**RESPONSE TO REQUEST FOR ADDITIONAL INFORMATION FOR LICENSE
AMENDMENT REQUEST REGARDING REALISTIC LARGE BREAK LOSS OF
COOLANT ACCIDENT ANALYSIS – RAI QUESTIONS 1 THROUGH 3
(NON-PROPRIETARY)**

**DOMINION NUCLEAR CONNECTICUT, INC.
MILLSTONE POWER STATION UNIT 2**

**Millstone Unit 2 M5® Upgrade, Realistic
Large Break LOCA Analysis RAI
Responses**

ANP-3316QNP
Revision 0

Figure 3—1 Example Axial Shapes – Peaking Comparison

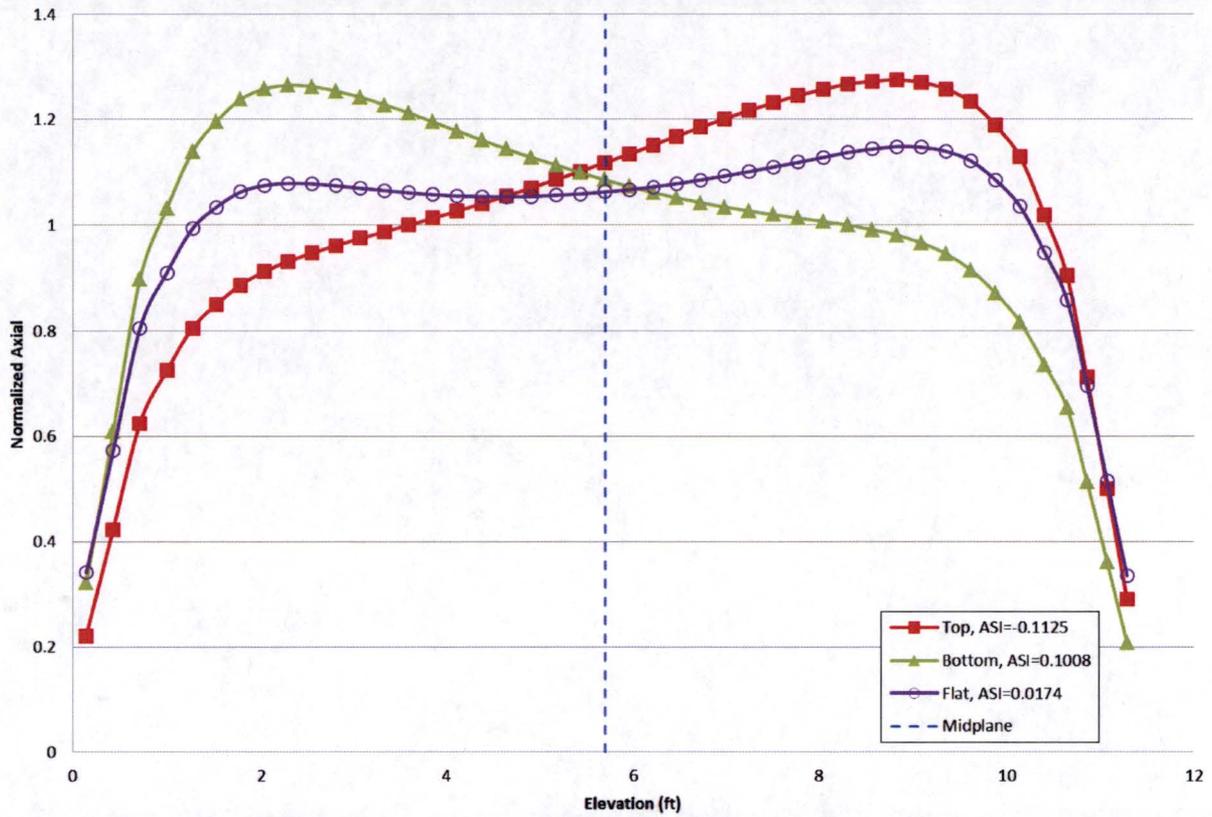
a) A strong trend was observed when reviewing the plot of the peak linear heat generation rate (PLHGR) versus the axial shape index (ASI). Please discuss how the PLHGR is used in the development of the axial power shape, why this strong trend exists, and how does this reflect physical plant operation.

b) There are several points that do not fall into the trend observed in Part a (e.g., point with sampled ASI of -0.0071). Please discuss if the plant can physically achieve these points or similar points that do not fall into the observed trend. If such points can physically exist during plant operation, please provide the maximum PLHGR the plant can achieve as a function of ASI over the range used in the analysis and please justify that the analysis results remain conservative.

Table A-1 of Reference [2] presents an “LHGR” value and an “ASI” value for each case. The LHGR value is equivalent to the sampled peak linear heat generation rate (PLHGR) and is a measure of the magnitude of power at the peak location. The ASI is the sampled fresh fuel hot rod axial shape index and is a measure of the difference between the power in the bottom half and the top half divided by the sum of the top and bottom halves. A plot of the PLHGR versus the ASI for each case shows the expected V-shape relationship between the two parameters: larger values of PLHGR values are associated with larger absolute ASI values. The V-shape relationship can be best explained using a plot of normalized axial shapes. Figure 3—1 shows an example of a top peaked shaped, a bottom peaked shape, and a relatively flat shape with their corresponding ASI values listed in the plot legend. As the axial shape becomes more skewed, the amount of power in the top or bottom region increases and the absolute value of ASI increases. As can be seen in the Figure 3—1, in order to skew the relative power in a region, the axial peaking increases and, accordingly PLHGR also increases.

However, PLHGR is associated with a single peak location in the rod, whereas ASI is a shape dependent indication of how the power is distributed over the full length of the rod. Because ASI is only a measure of relative power between regions, it is possible for shapes to have a moderate PLHGR and a low absolute ASI, like the case identified in RAI-2b.

During operation, the plant monitors the core power distribution in accordance with the Technical Specifications. It performs this function by continuously verifying that the core ASI and LHGR are maintained within the allowable limits specified in the Core Operating Limits Report (COLR). For the RLBLOCA uncertainty analysis, a set of axial shapes with ASIs supporting the plant's COLR operating barns and Technical Specification limits are generated. The process used in selecting the axial shape from those provided is described in Sections 9.3.1.3 and 9.3.1.4 of Reference [1]. The set of axial shapes is utilized in the sampling process and the selected axial shape is used without modification in the analysis. Accordingly, the relationship between ASI and PLHGR is maintained and that relationship is representative of plant operation.

All the sampled case axials in the analysis described in Reference [2] were derived from the axials provided for Millstone Unit 2. While larger PLHGR and, due to the relationship, larger absolute ASI values tend to result in more limiting PCTs, there are many other considerations and sampled inputs that will impact the magnitude of the PCTs. For instance, Figure 3 of Reference [2] shows the strong relationship of the PCT results to the break size input. The RLBLOCA method is a statistically based method and does not strive to make each case the most conservative result. The case-specific LOCA results are representative of the population of possible LOCA events for a given plant. From the set of all the case-specific results, the reported LOCA results are determined in order to provide a high confidence that the 10 CFR 50.46 criteria are met.
